Access Compliance Report

Public Rights-of-Way

(Curb Ramps)

Intersection ID: N/A	Main Street: SPEER_BV	Cross Street: NATIONAL_AV	Location: W
ADA ID: C7A794AB50BC	Ramp Type: Perp	Initial Pass/Fail: Fail	Overall Compliance: No
Severity Score: 12.5			
Codes/Mitigation Info/Possible Solution		Field Measurements/Component Compliance

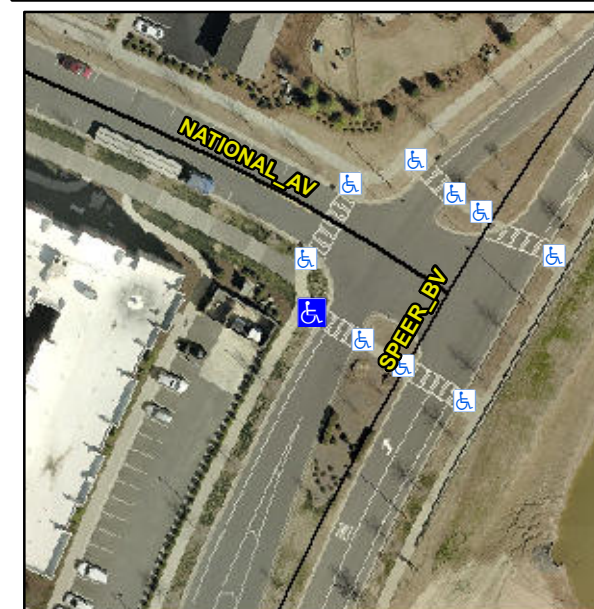
Not Found, R304.2.2

Remove & Replace Entire Ramp.
